ADDENDUM NO. 2

Kau Water System Improvements – Phase 1

IFB No.: IFB-20-HHL-019

DWG. NO.
C-10
SHEET 12 OF 54

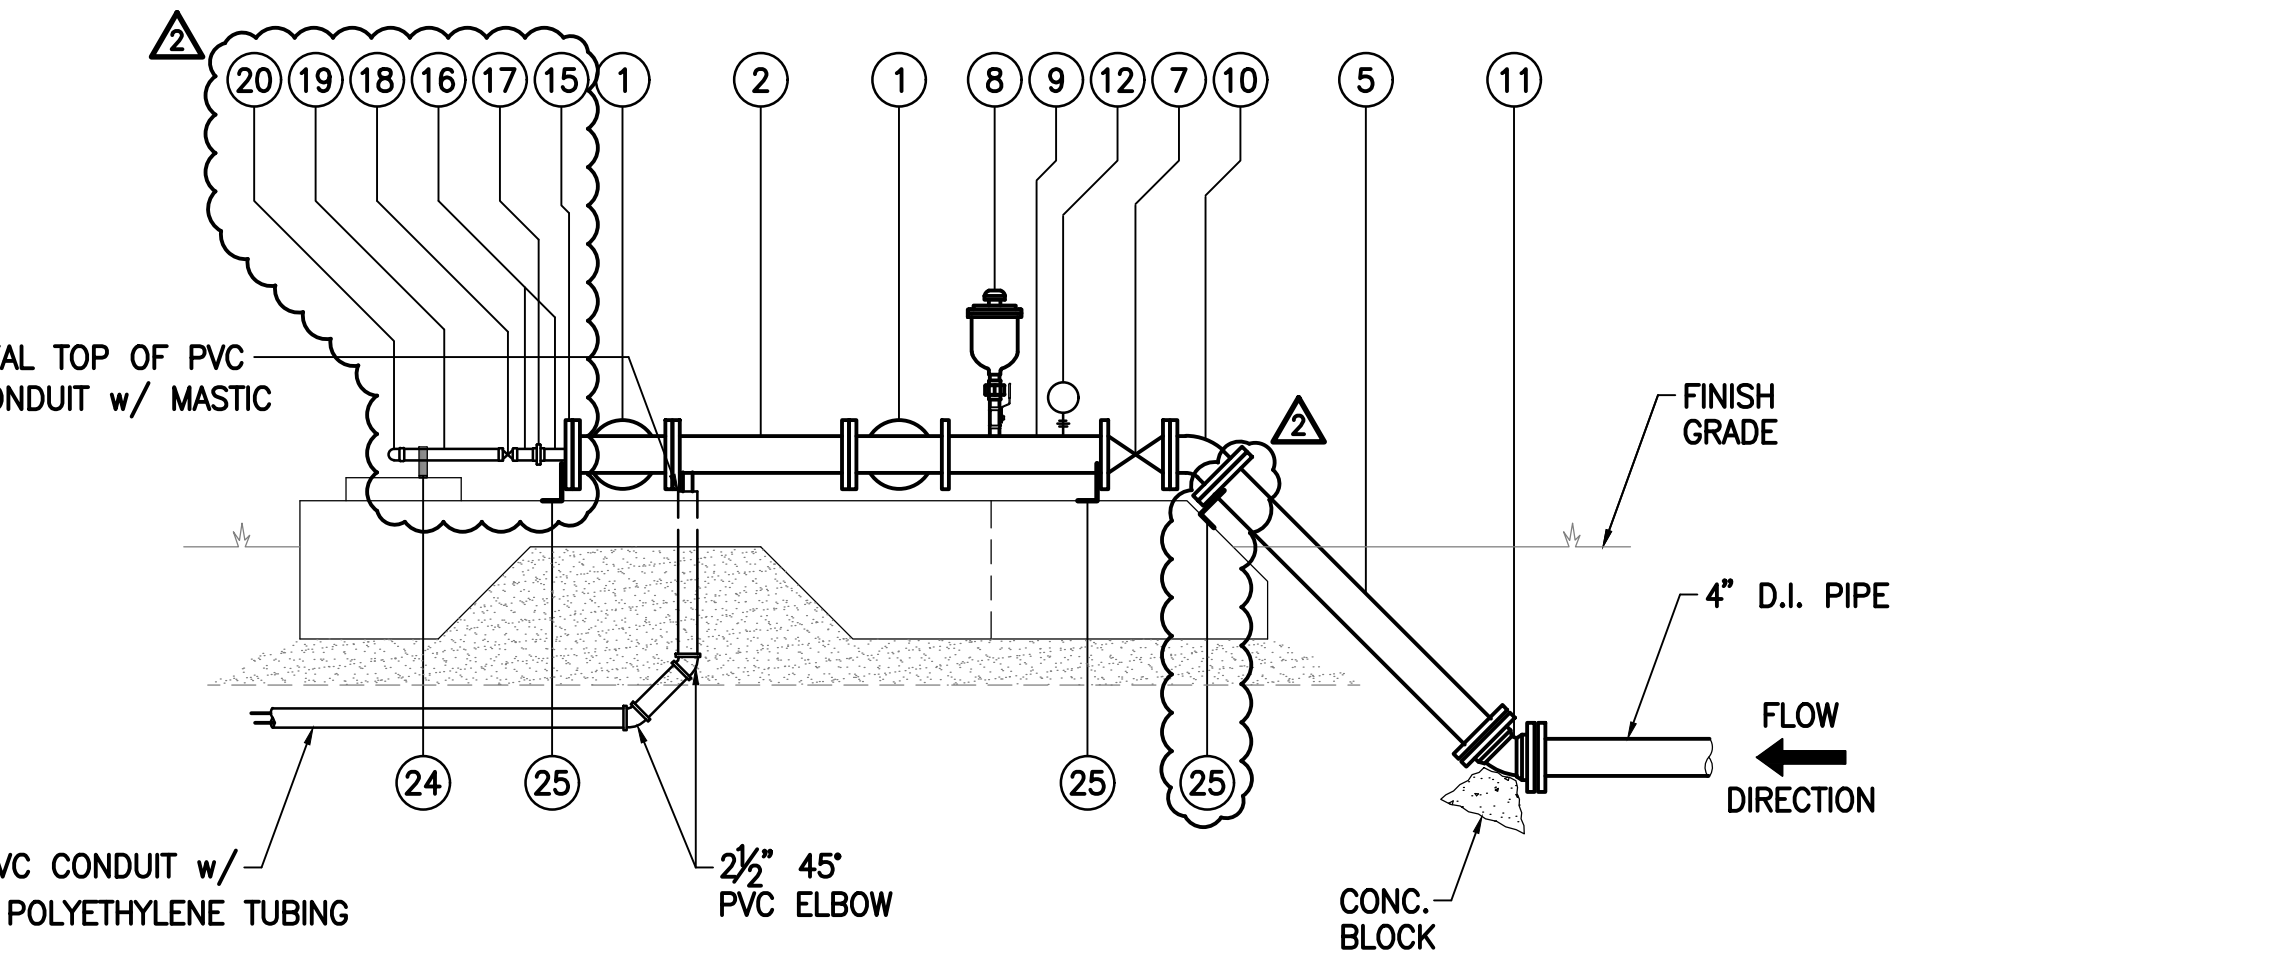
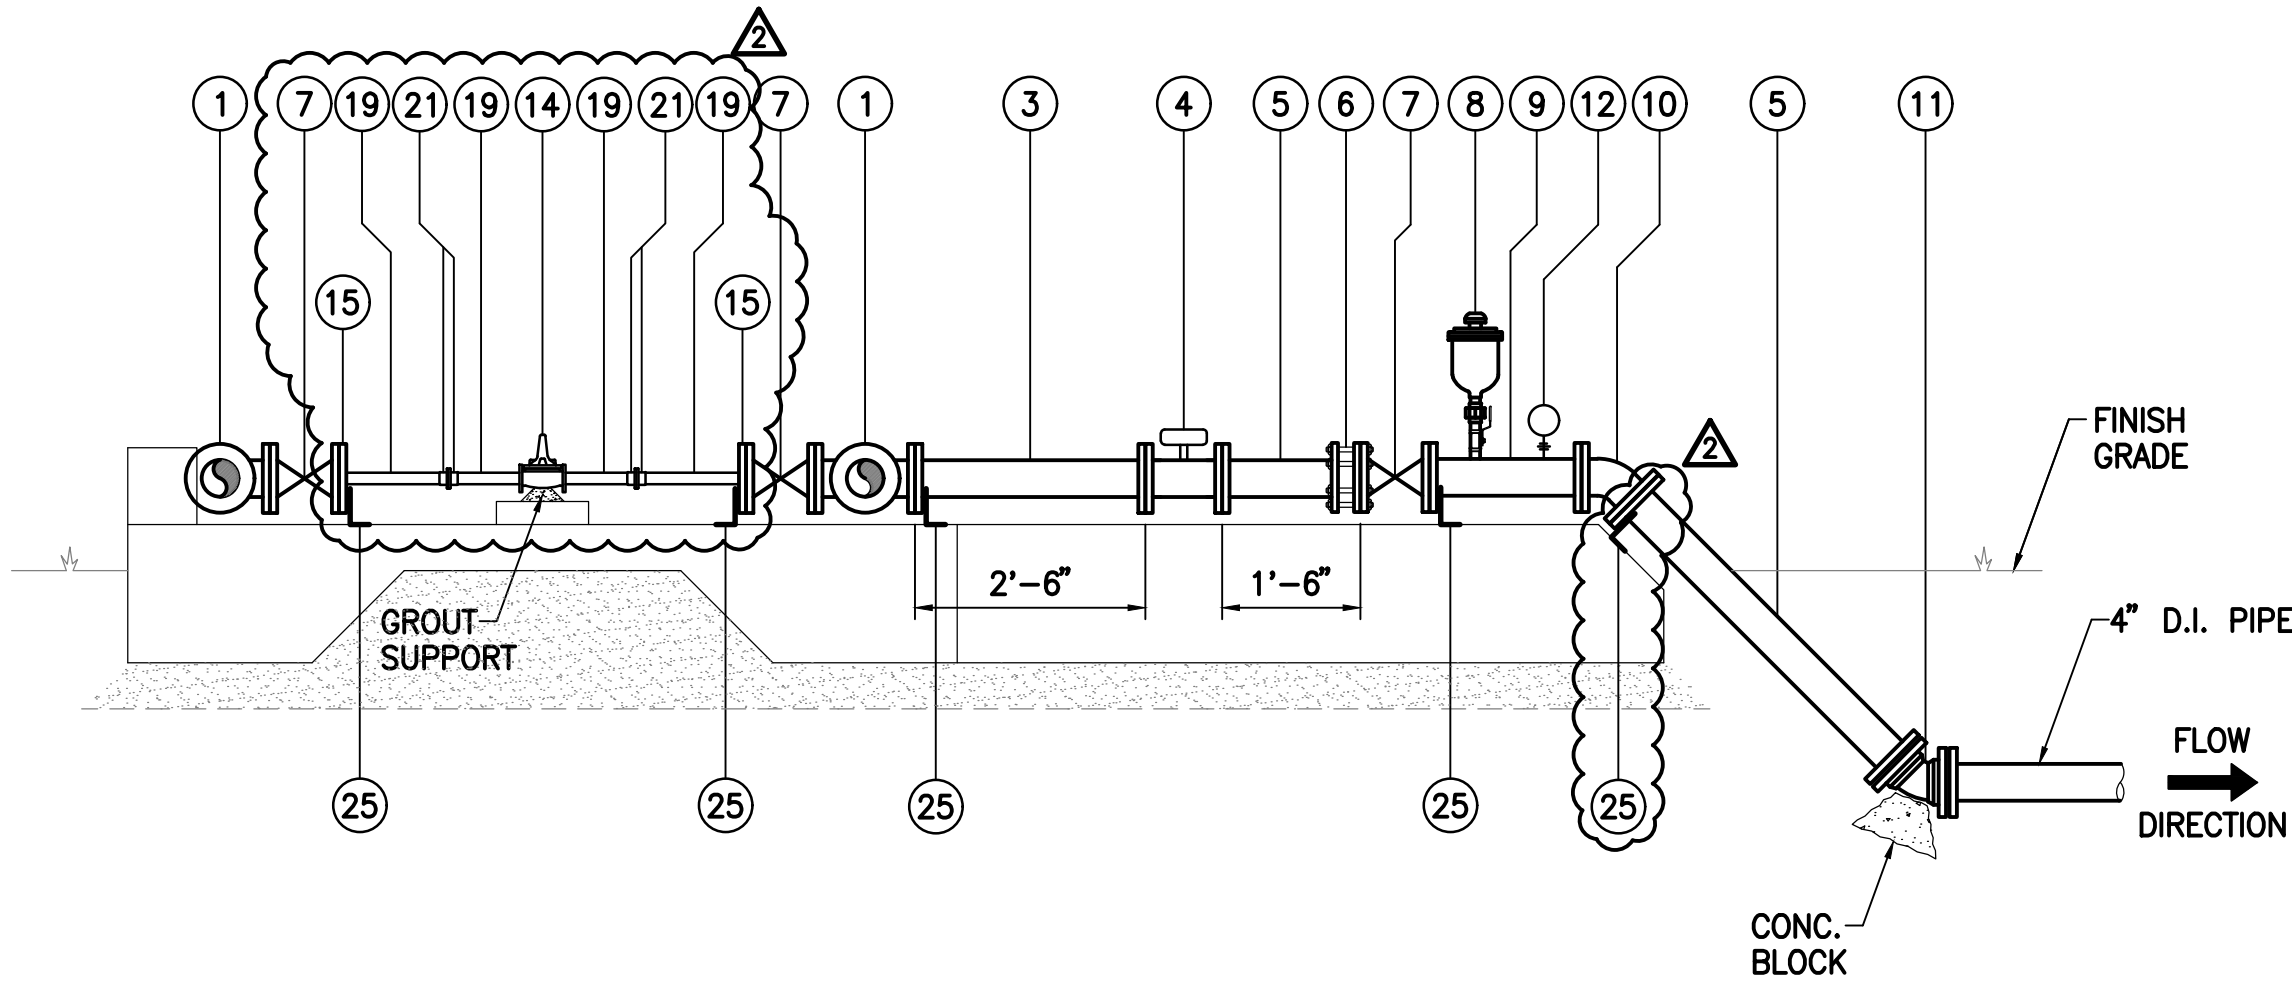
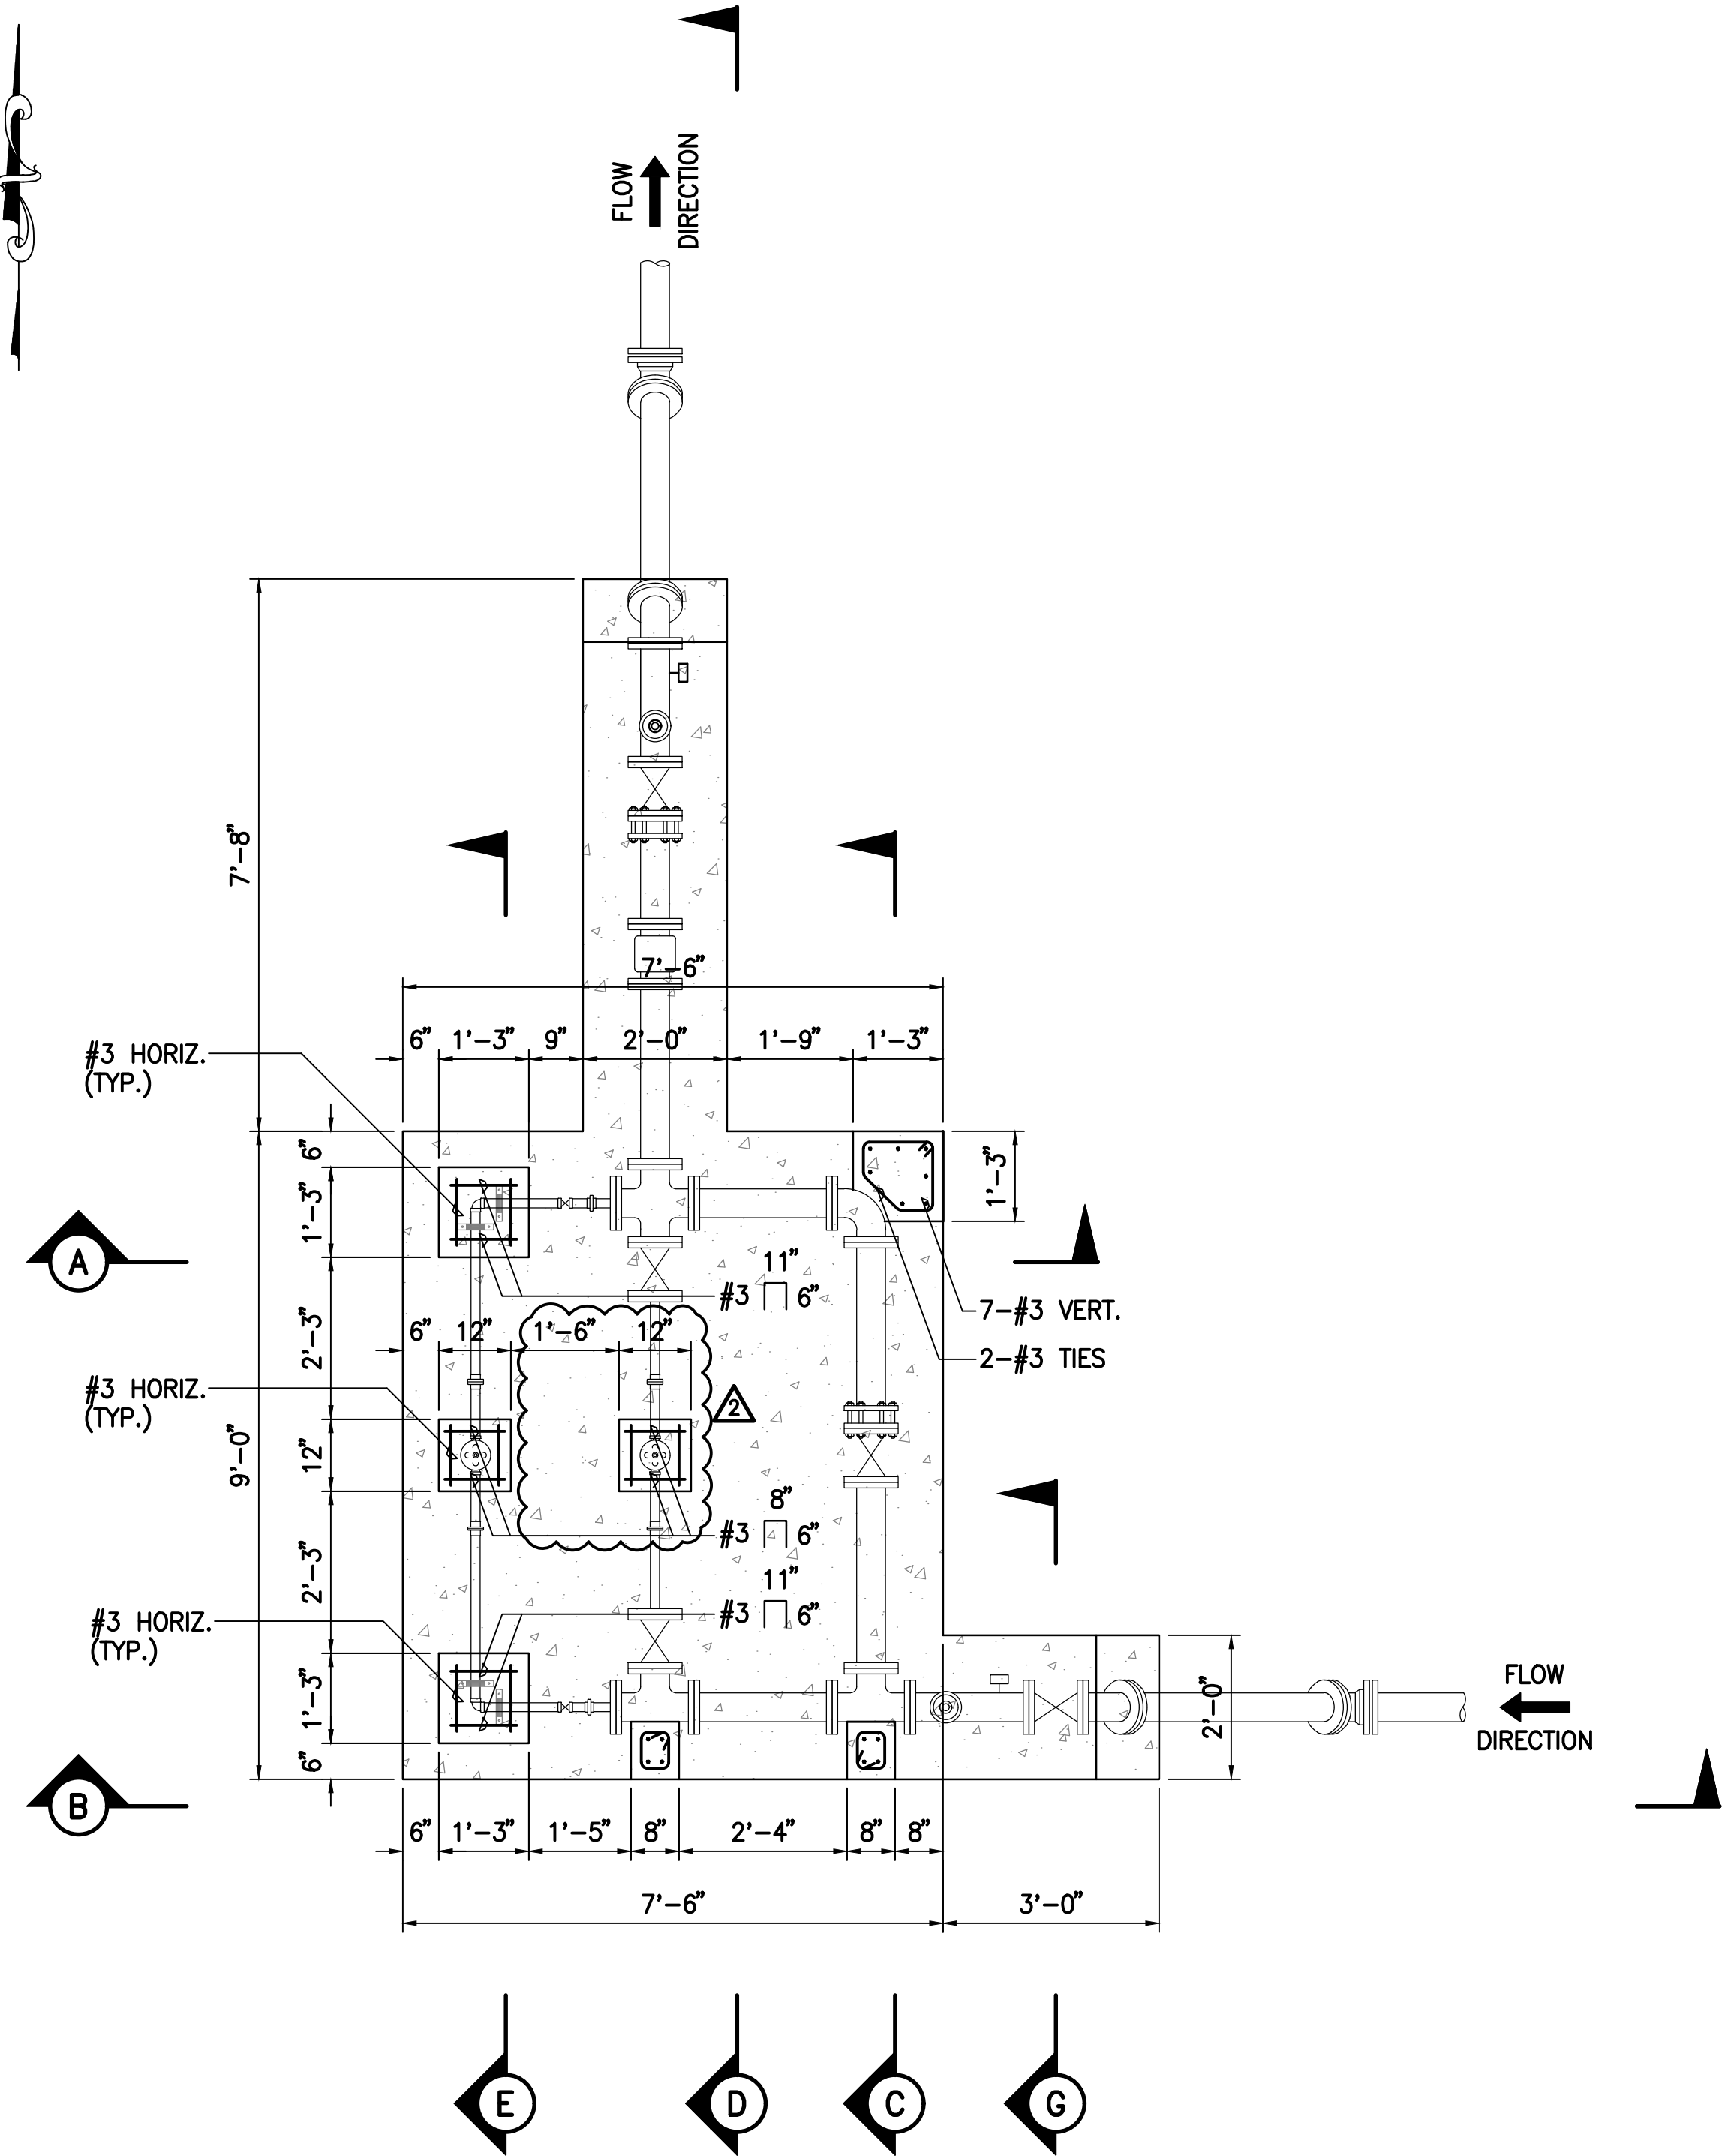
6. PLANS: Drawing No. C-10 - Revisions include revising the sectional views of the reservoir influent control valve station to suit its revisions described for Drawing No. C-9 above; delete Section F.
